**TOWN OF LOS GATOS
PLANNING COMMISSION AGENDA
SEPTEMBER 09, 2026
110 EAST MAIN STREET
TOWN COUNCIL CHAMBERS
7:00 PM**

SUBJECT: Consider an Appeal of a Community Development Director Decision to Approve a Request to Construct a Second-Story Addition to an Existing Single-Family Residence on Property Zoned R-1:8. **Located at 16717 Chirco Drive.** APN 424-20-014. Minor Residential Development Application MR-24-018. Categorically Exempt pursuant to the California Environmental Quality Act, Section 15301: Existing Facilities. Property Owner: Deepak Gupta. Applicant: My Troung. Appellant: Zahra Hajihashemi. Project Planner: Maria Chavarin.

Re: Objection to Proposed Two-Story Addition at 16717 Chirco Drive, Los Gatos, CA 95032 (APN 424-20-014) — Application No. MR-24-018 / Revised Plans dated 02/23/26 (Bay Area Project Pro)

PROPOSED PROJECT

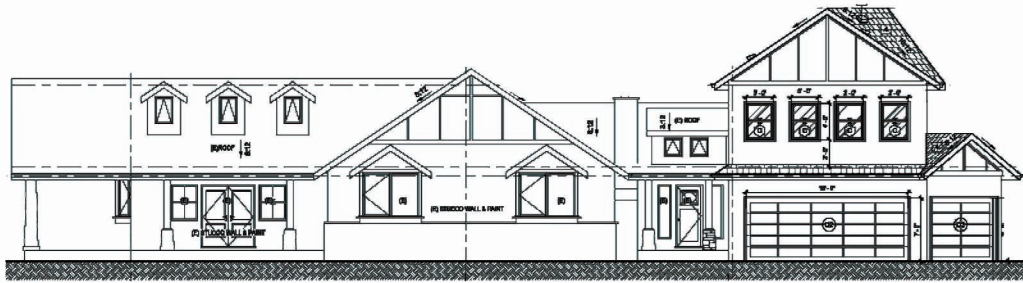
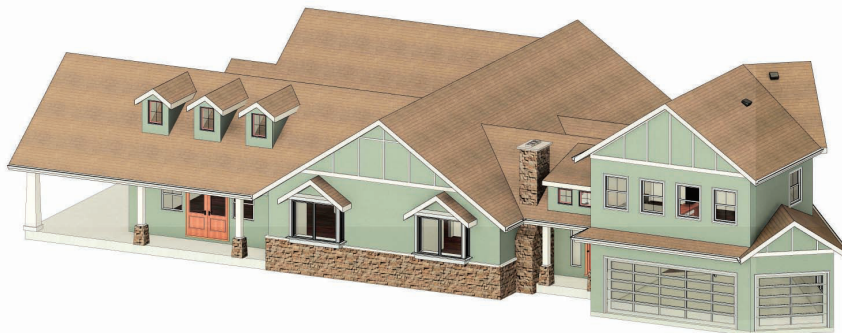
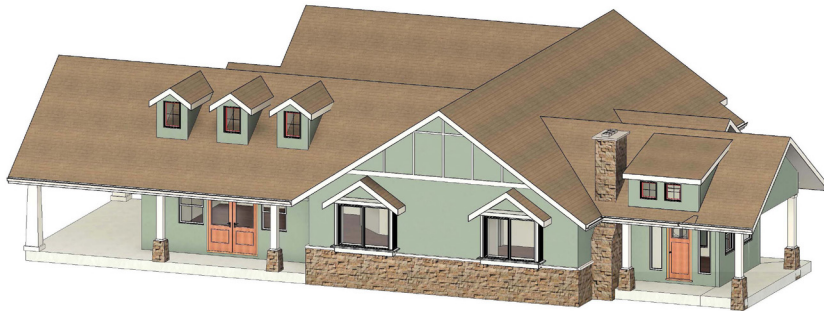
The existing house is a very well designed one story Ranch Style home with floor plan and roof forms typical of the style - see existing house sketches below.

1. The addition is very awkward and not consistent with the Residential Design Guideline 3.1 Principles.

1. Eliminate the awkward angled garage volume on the front facade.
2. Eliminate the awkward angled rear facade gable end.
3. Redesign the addition building form to be more reflective of the existing house and the proposed architectural style.
4. Eliminate the circular driveway and replace a significant amount of the hardscape driveway paving with landscaping.
5. Select garage doors with solid panels and limited transparent glazing.

Figure B0. The proposed second story (green star) does not immediately abut the subject neighbor's property line (red star and red line). The correct direction between the two structures is Northeast (not East).

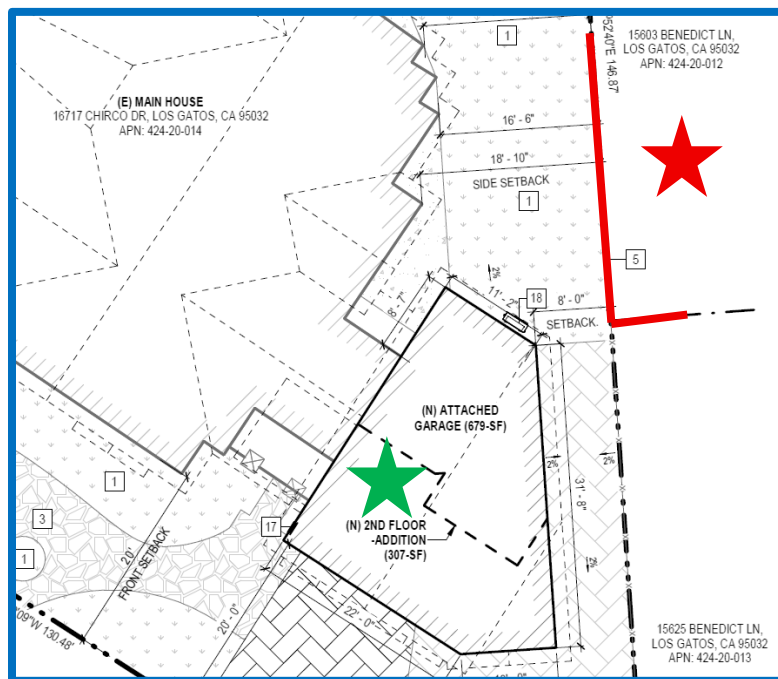
The neighbor's conceptual exhibit was also reviewed and appears to depict a very long, low-angle shadow. However, the exhibit itself is labeled as conceptual and is not a scaled or surveyed shadow study so it is unclear exactly how to use this. From a geometric standpoint, an approximately **85-foot shadow** from a **26.5-foot-tall structure** would require a sun elevation angle of only **17.3 degrees above the horizon**. This represents a very low-angle sun condition, typically associated with dusk rather than standard daytime conditions. It is not typical for shadowing during dusk to have material adverse impact, as **it is brief and expected** before sunset. The conceptual drawing is also inaccurate as it positions the subject neighbor directly east of the proposed second story which is not accurate. An accurate figure depicting the proposed configuration is included here with no immediate abutment along his property line (15603 Benedict) line.

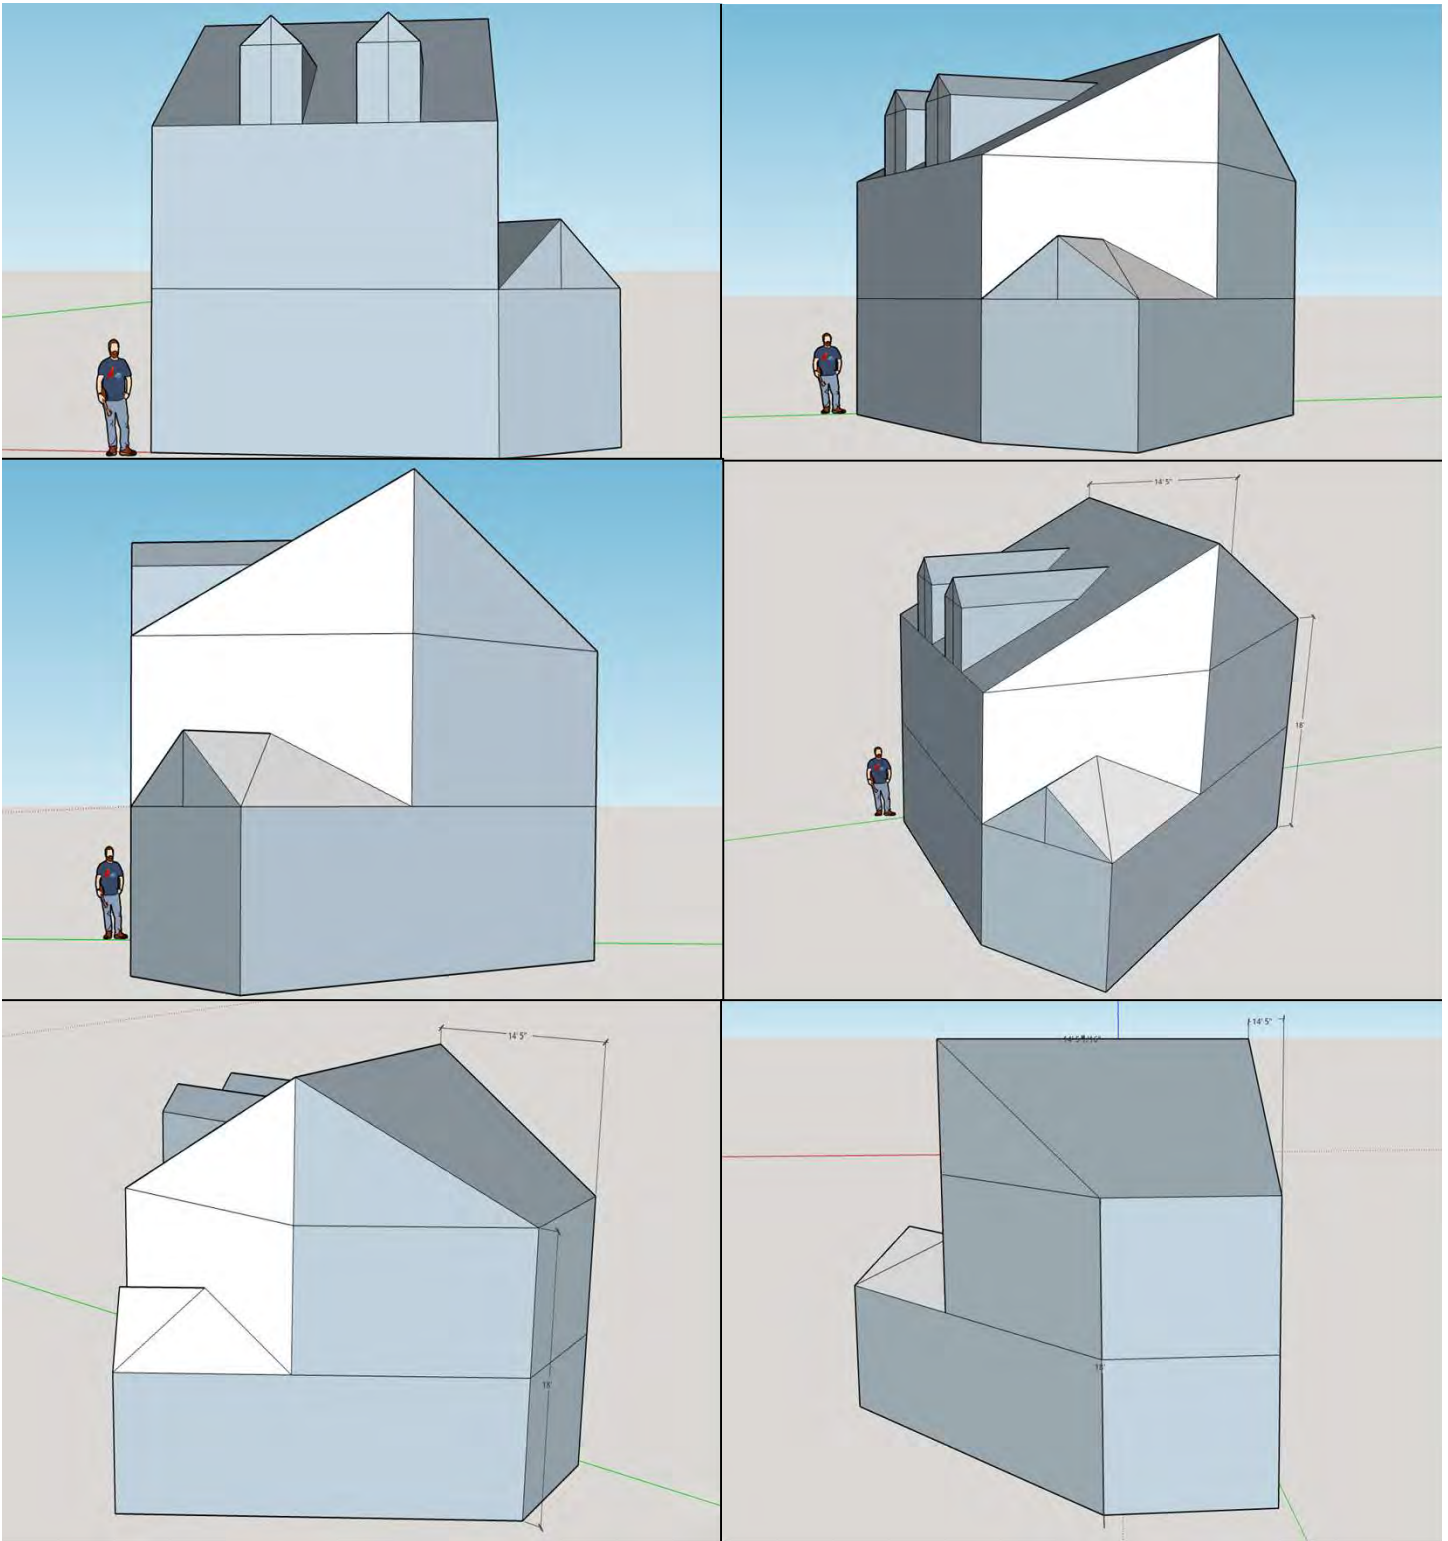
Figure C9-C14. A second possible alternative roof design is included to blend gable and hip styles to reduce rear height and still maintain some architectural consistency. Due to the short notice of this response, this conceptual design has not yet been fully designed or engineered to assess viability. Dormer windows would blend well with existing structure.

Figure 4: Proposal to construct the living area in A and eliminate the side windows and area B.

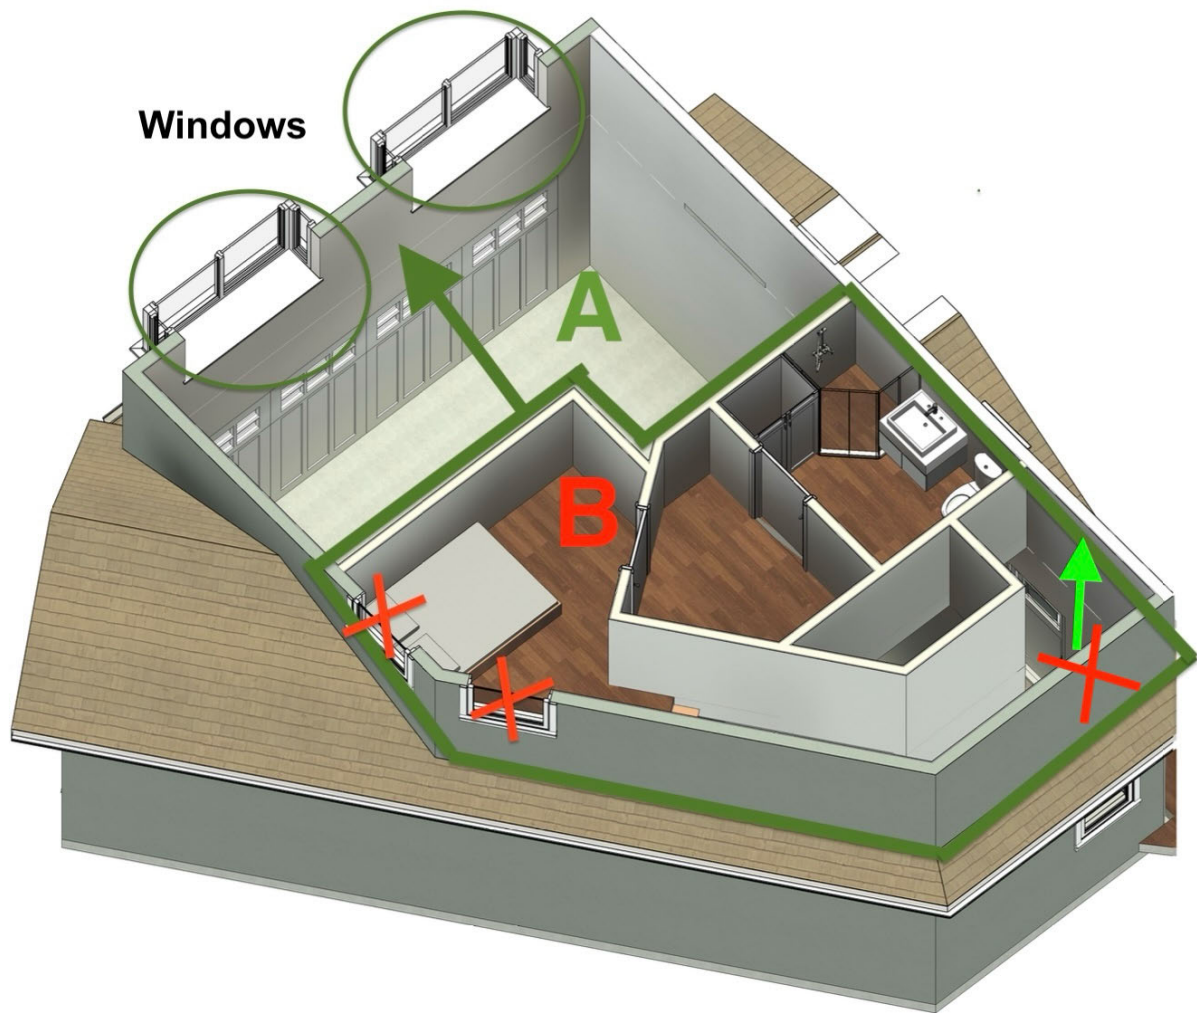
D. Suggestion #1 to reduce mass and address privacy concerns: To address both mass and privacy impacts, we identified an open area (area A in Figure 4) adjacent to the living area on the second floor (area B in Figure 4). The living area B could be constructed within area A, adjacent to the street-facing windows, thereby utilizing the street-facing windows and eliminating the necessity of having two windows facing our backyard (marked with red crosses in Figure 4). The third window can be eliminated by constructing a window on the west-facing wall (indicated by the green arrow in Figure 4). These modifications would address privacy concerns by eliminating the unwanted windows, while simultaneously reducing mass by eliminating the unoccupied area (area B).

Figure 5: Proposal to construct the second story unit adjacent to the existing house.

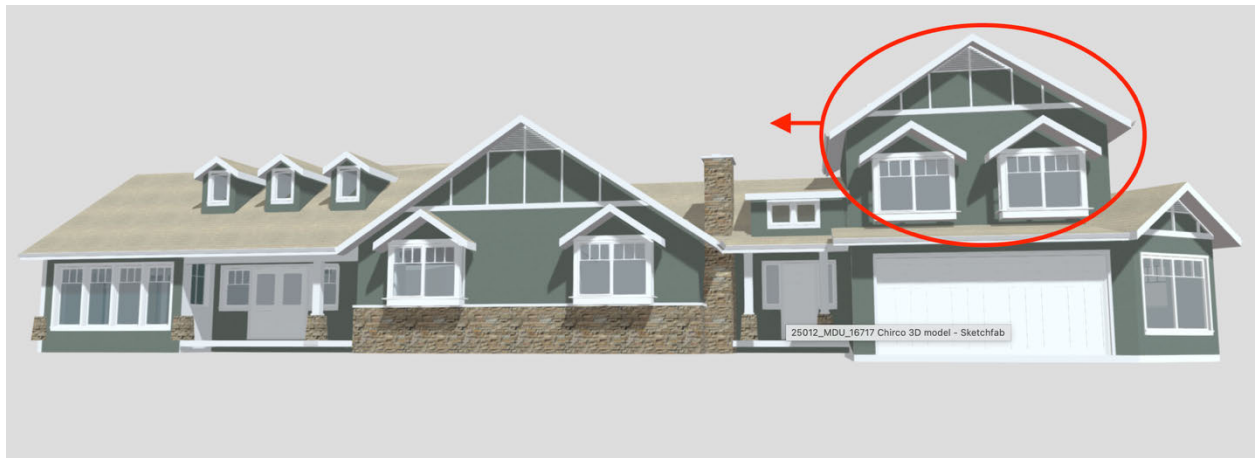
E. Suggestion #2: Another suggestion to address mass and privacy concerns is to construct the second story closer to the main house (Figure 5). For this option to be effective, it should be combined with relocating area B to area A, eliminating the side windows, and removing the additional space. This comprehensive approach would effectively address both the excessive mass and privacy issues.

Figure 6: Design modifications to address mass, height and privacy concerns.

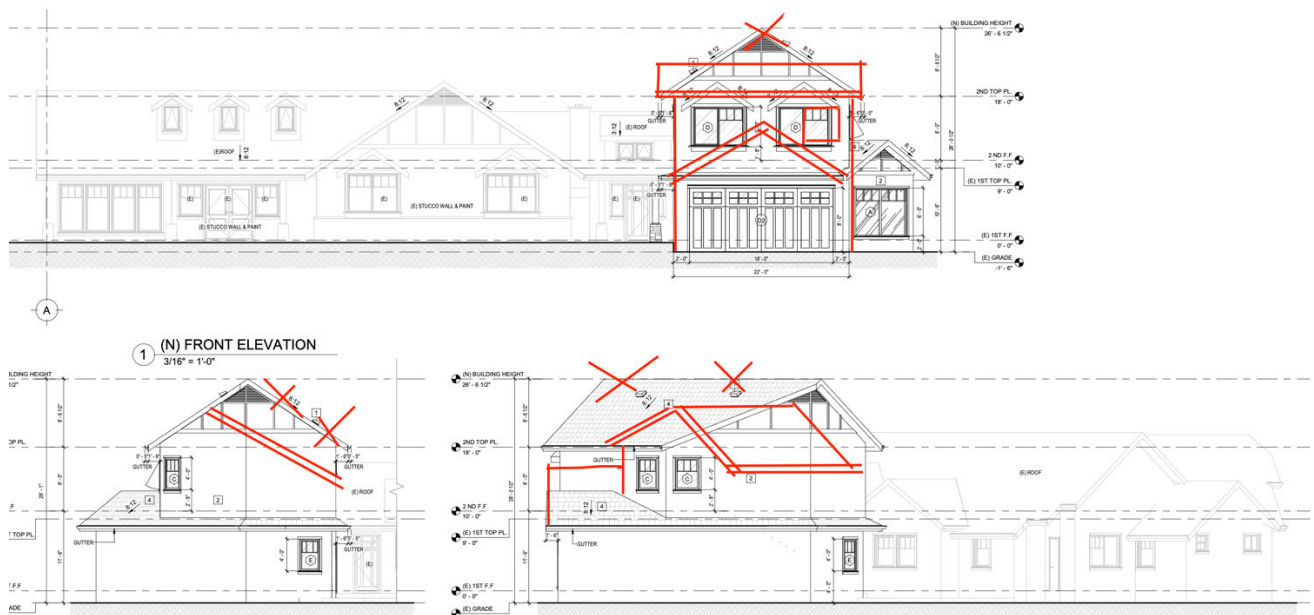
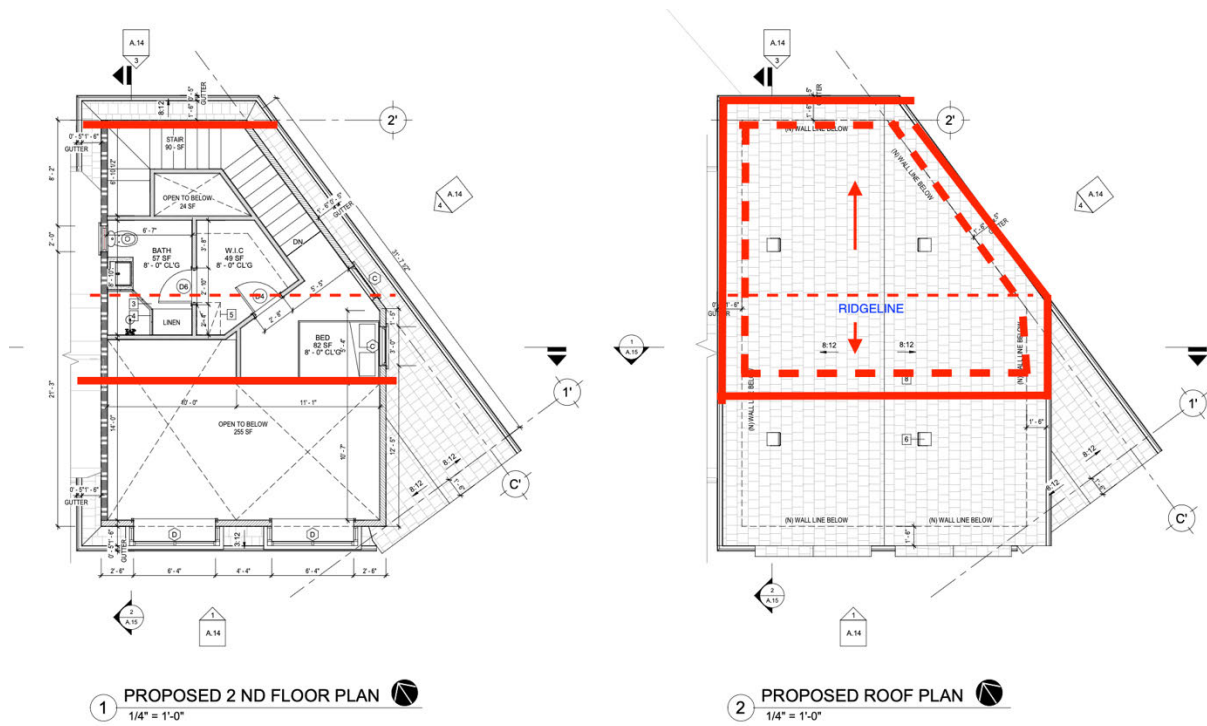
F. Suggestion #3: Figure 6 presents additional modifications that address our concerns without reducing the square footage. Please note that, all the above-mentioned suggestions are merely preliminary proposals to demonstrate that our concerns can be addressed with reasonable
